TITLE: Furnish Labor and Materials for Renovations to the A.C. Buchanan Building LSUA

Project: Renovations to the
A.C. Buchanan Building
Louisiana State University Alexandria
Architects' Project Number 2024.33

RE: Addendum Number Two (2)

WINDOW HEADER DETAILS (STOREFRONT SYSTEM OPTION)

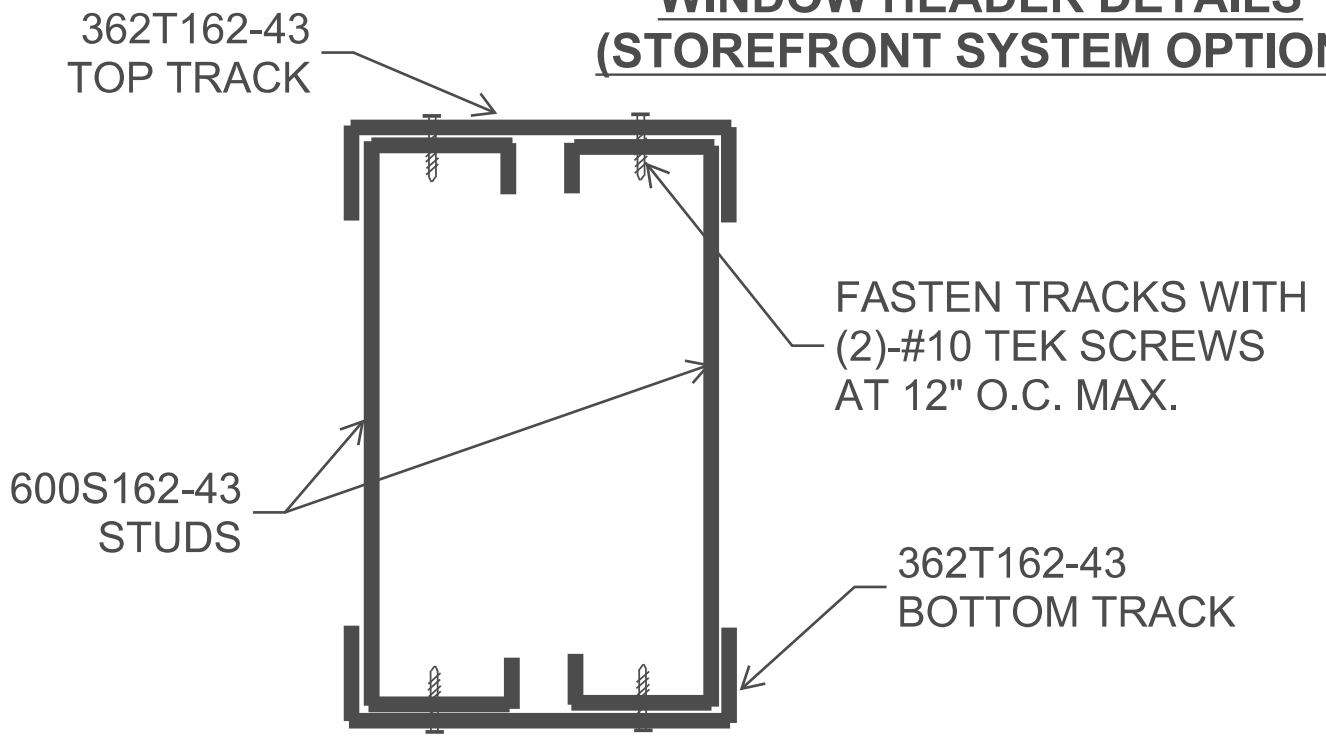
23. Re: DRAWINGS:
 - a. Accompanying this addendum is a sketch labeled Window Header Details (Storefront System Option)
 1. Refer to detail 2/A3.0, window type “H” for header location

2. This design provides an alternate option to the 4x 4 steel tube referenced in keynote 136 on detail 10/A5.1
